# PARTS & SERVICE NEWS

REF NO. AA01141A

**SUBJECT:** INSPECTION AND REPAIR OF AXLE BOX

**APPLICATION:** Komatsu 930E Dump Trucks AFE48 & Up, A30019, A30026 & Up

FIGURE 2. DRILLED RING (EJ4433)

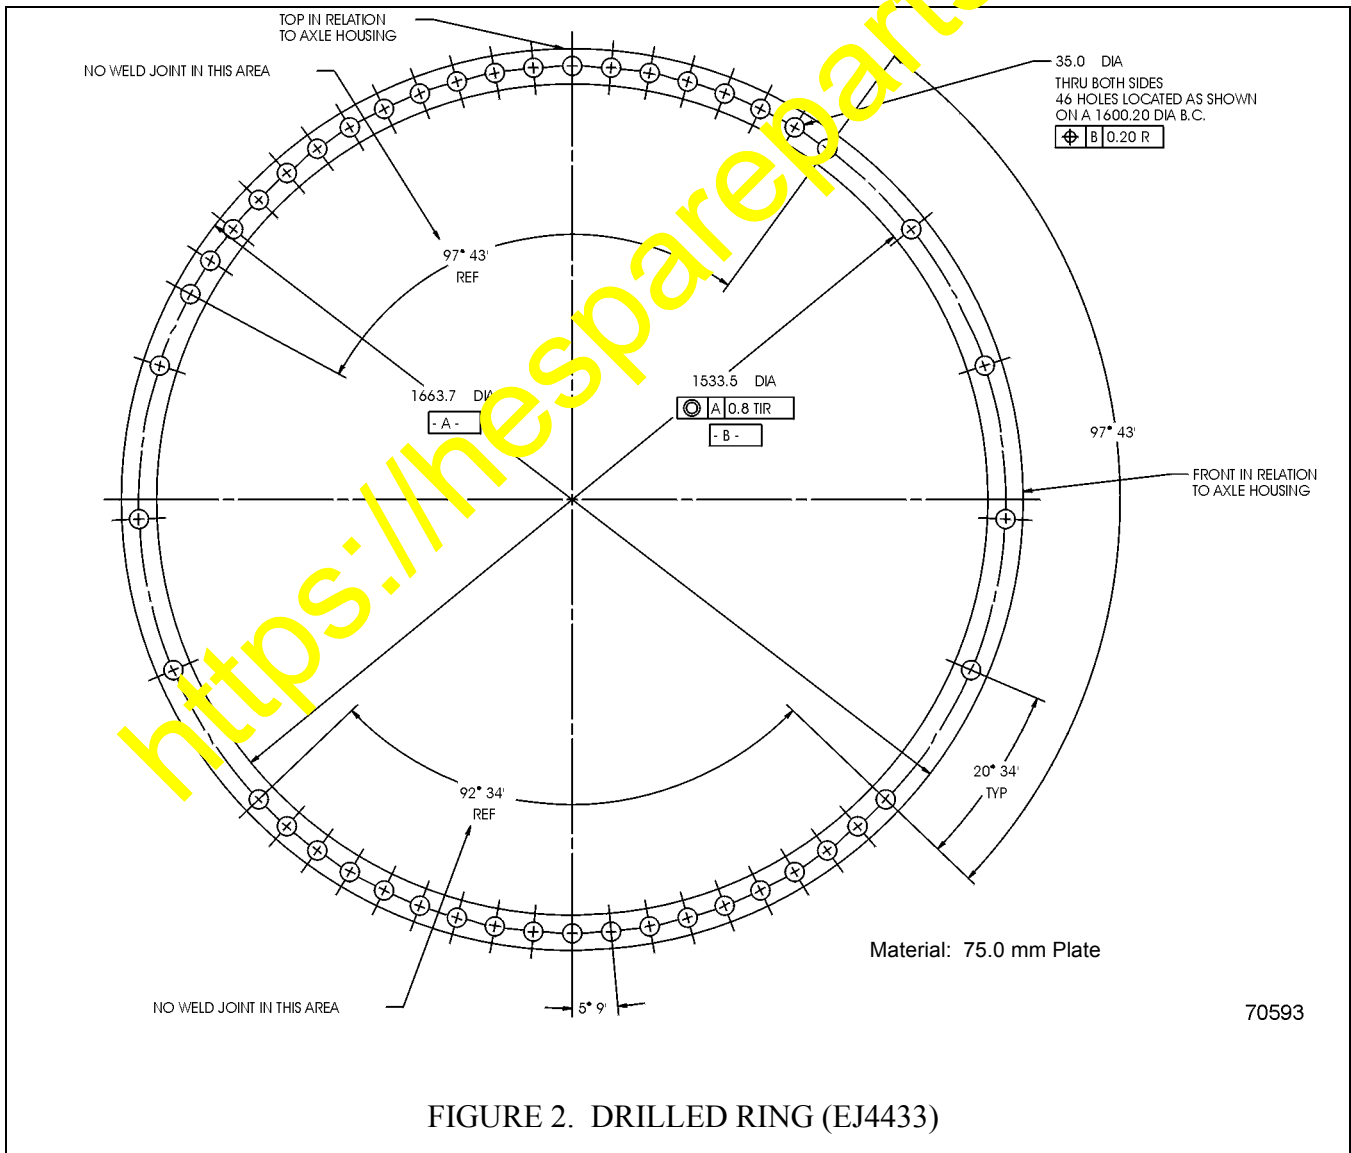
2. Using a lifting device, set a drilled ring to the Mount Ring. Use at least 17 bolts to hold the drilled ring to the housing. The drilled ring retains the flatness of the Mount Ring during the repair process.
